EASTERN CORRIDOR SEGMENTS II AND III (PID 86462)

COMBINED LINWOOD/EASTERN INTERCHANGE & US 50/RED BANK INTERCHANGE FOCUS AREAS ADVISORY COMMITTEE MEETING NOTES

February 14, 2018
May 22, 2018
September 7, 2018
December 12, 2018

Figure X-2B-3 and EW-2
 GRADE SEPARATED INTERCHANGE TO CONNECT
 WILMER AVENUE TO WOOSTER ROAD

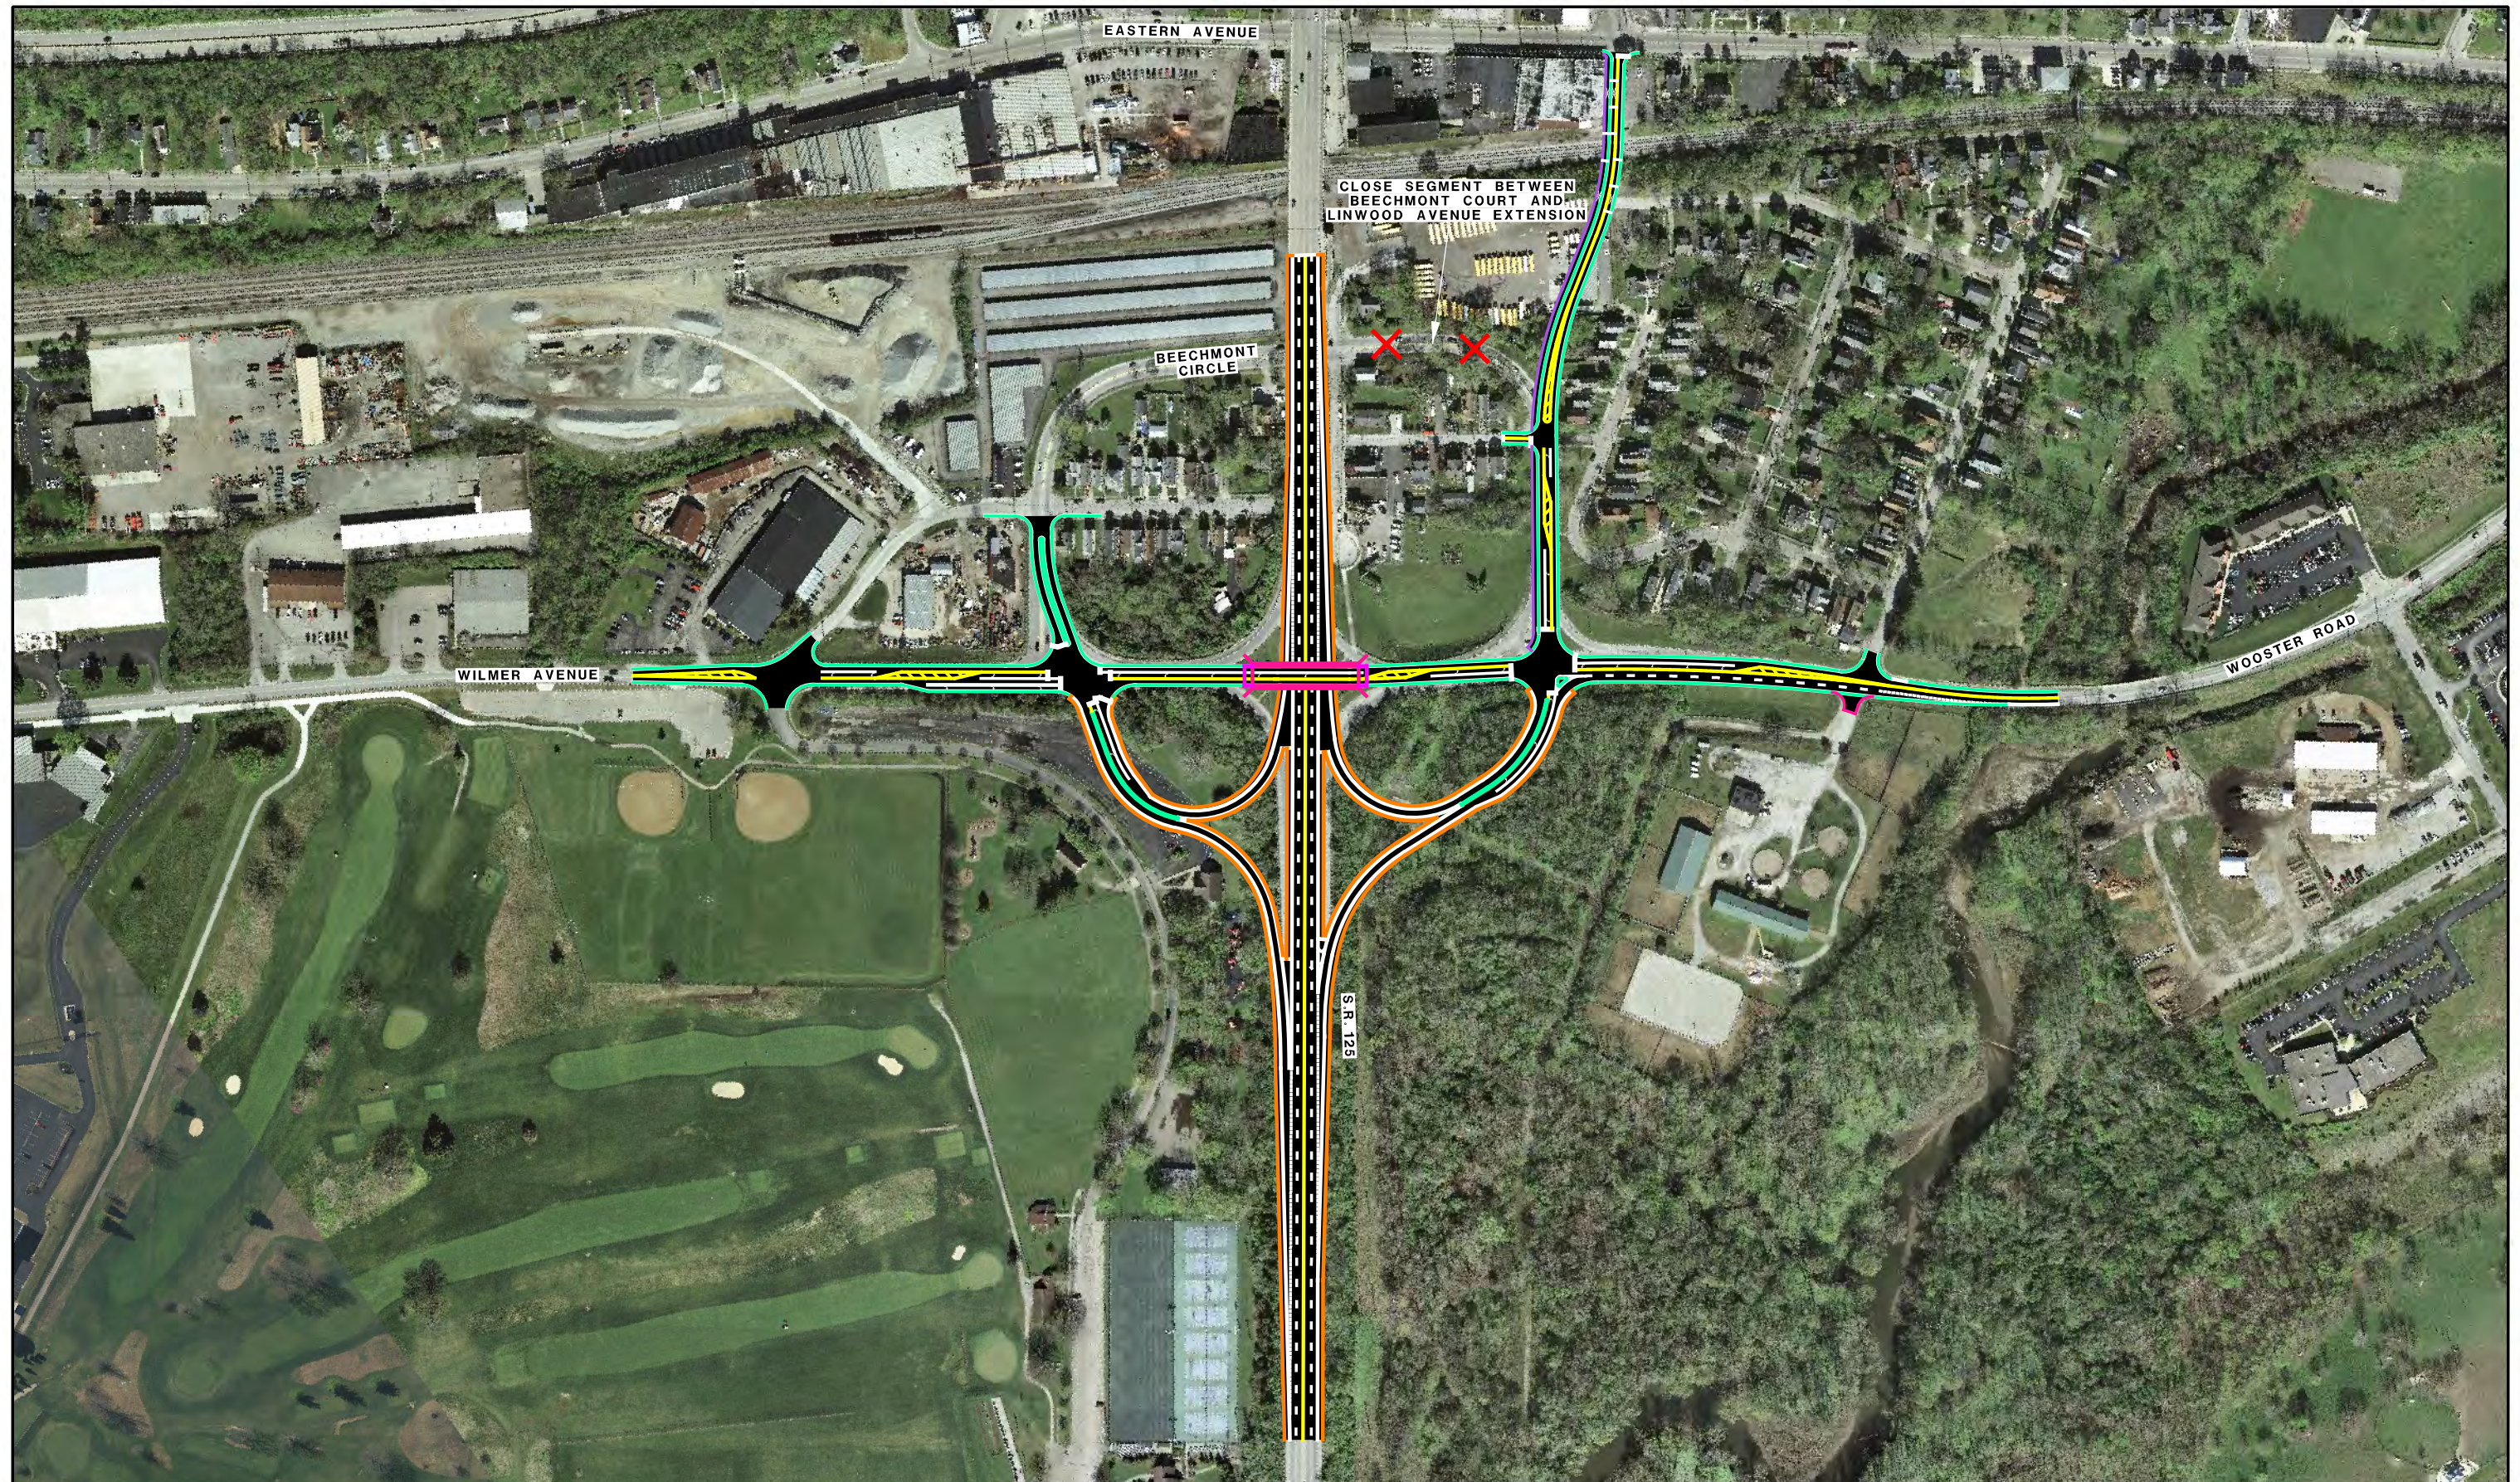
- Will the three-way intersections on either side (East and West) of the proposed grade change connection of Wilmer and Wooster be signalized, or stop signs? Concern this will slow flow of traffic compared to current design

- No further study. This concept is the same as X-2b-2, which is preferred because it provides a lower speed ramp to connect Wilmer and Wooster compared to this concept.

RECOMMENDATION: NO FURTHER STUDY

Figure X-2B-4
GRADE SEPARATED INTERCHANGE TO CONNECT
WILMER AVENUE AND WOOSTER ROAD

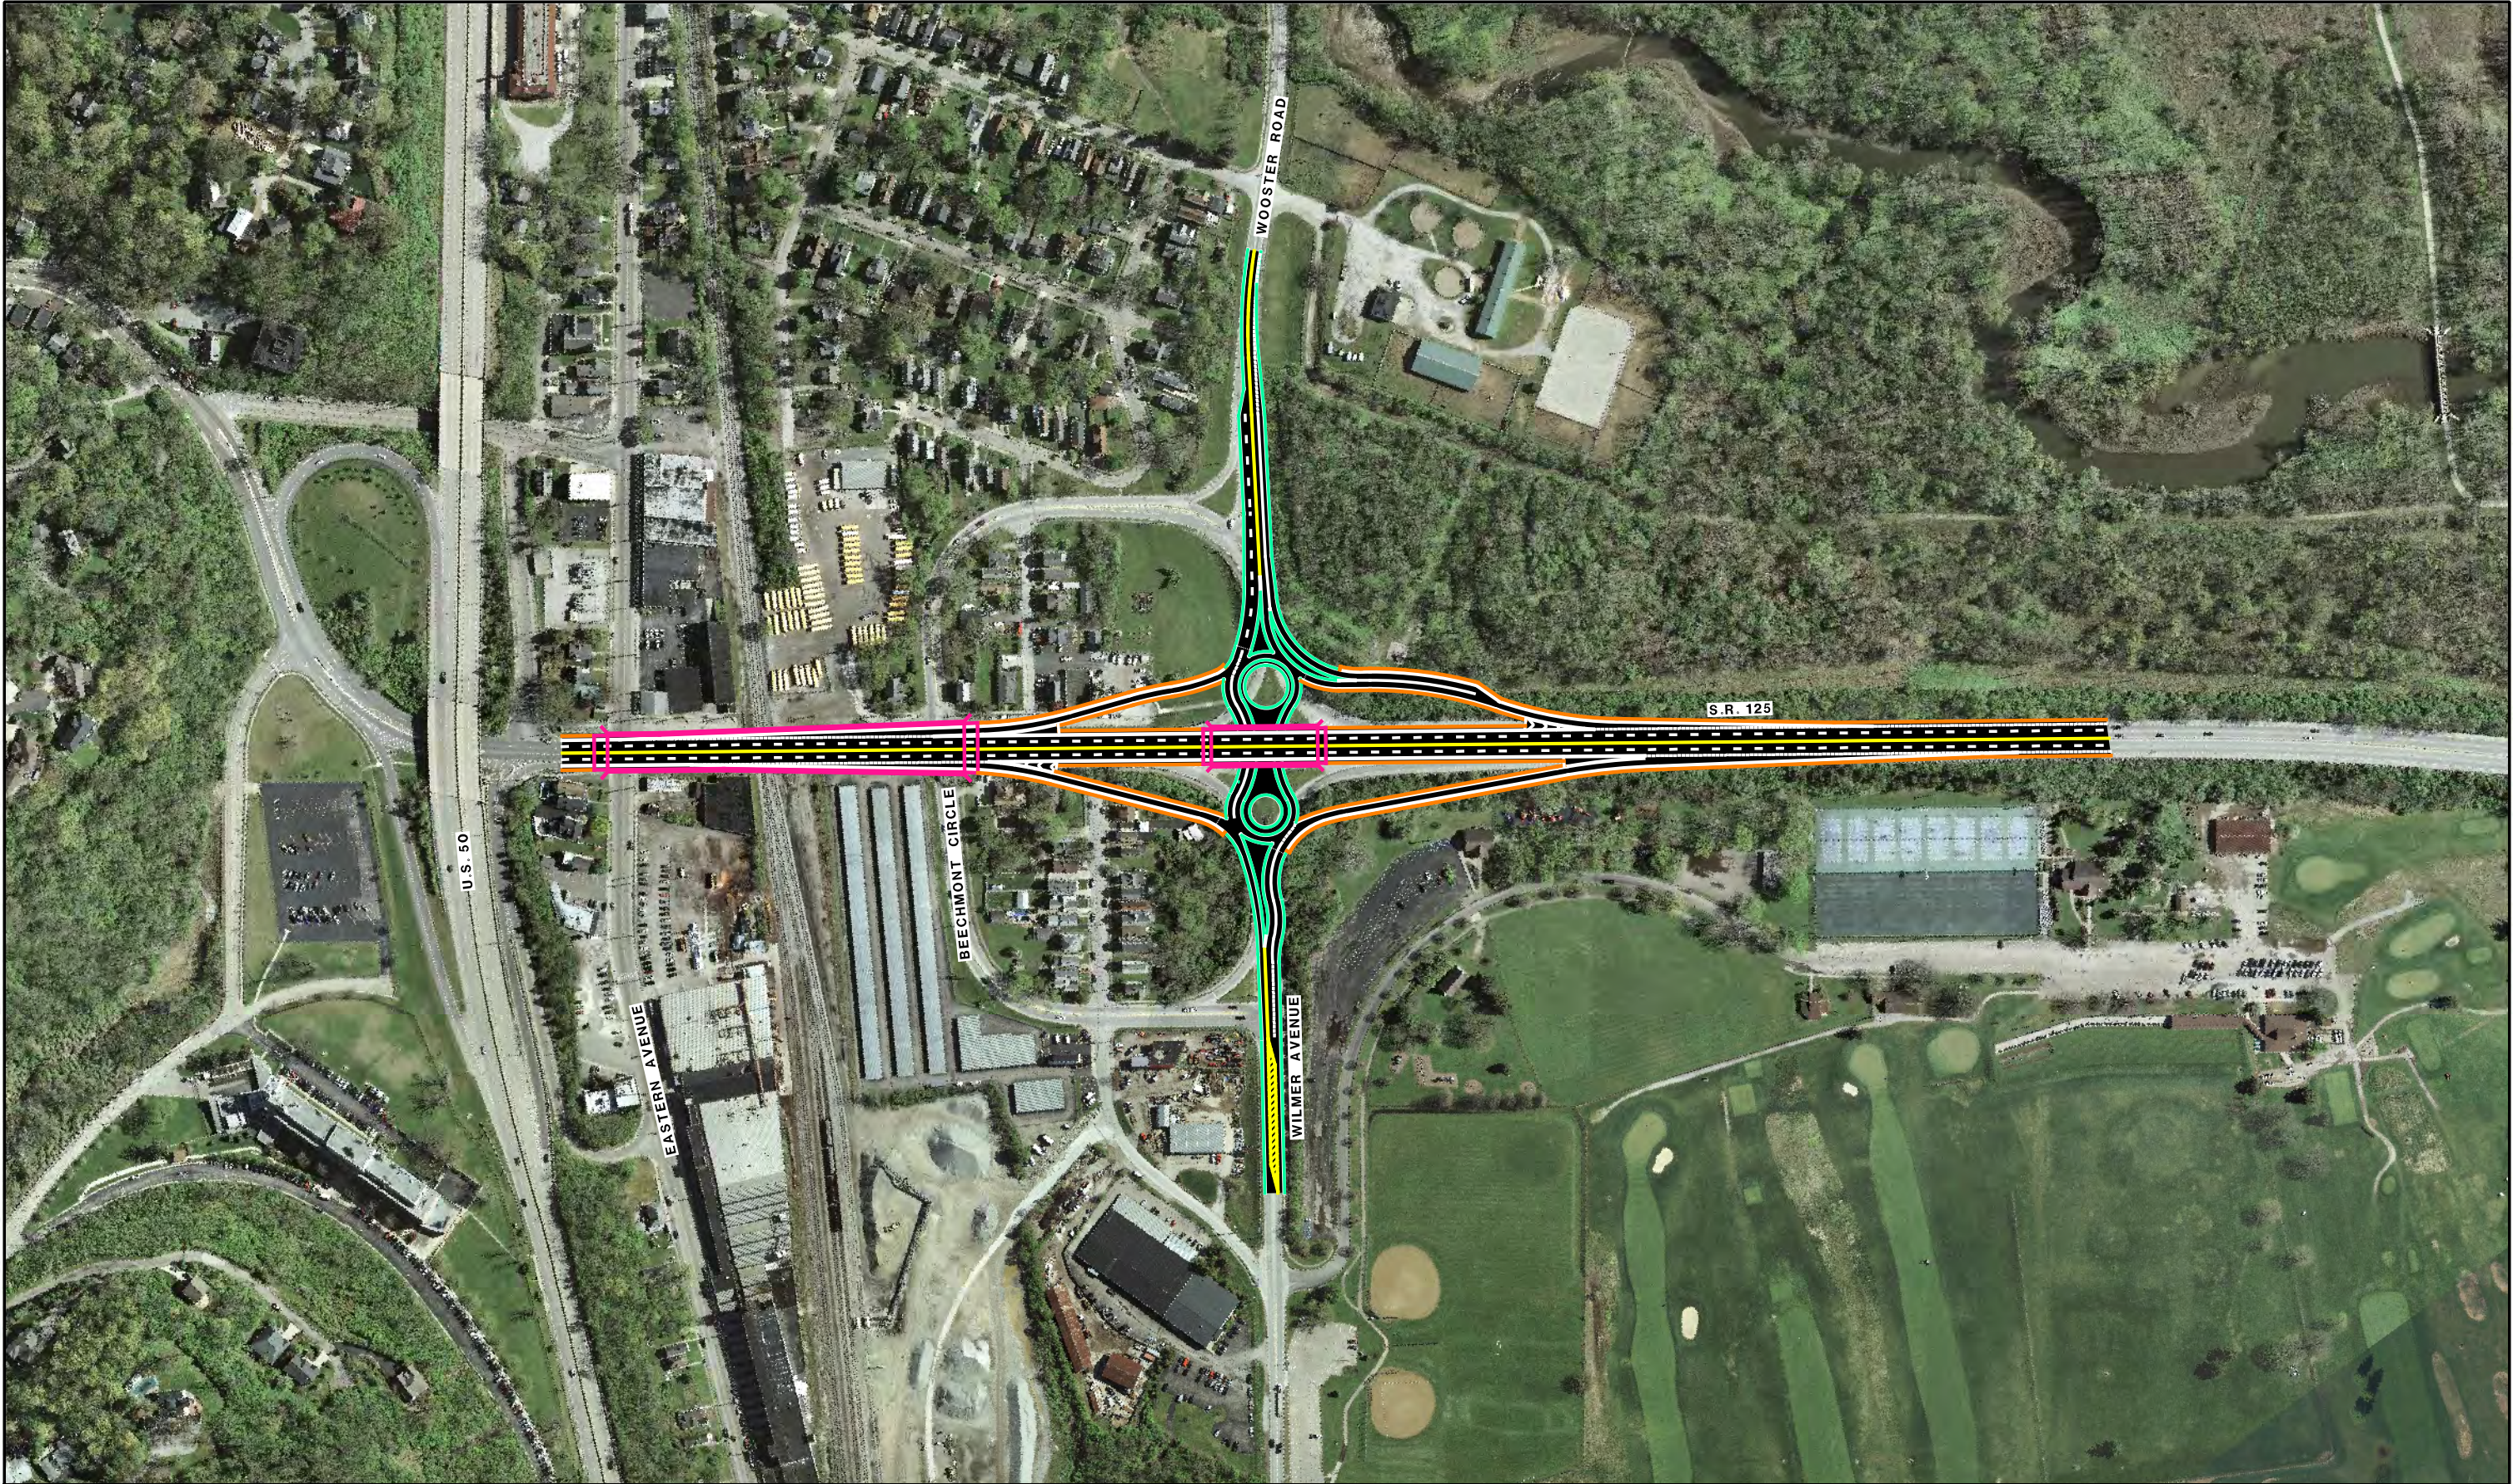
- P2) Address localized connectivity travel patterns within Beechmont Circle.

RECOMMENDATION: NO FURTHER STUDY
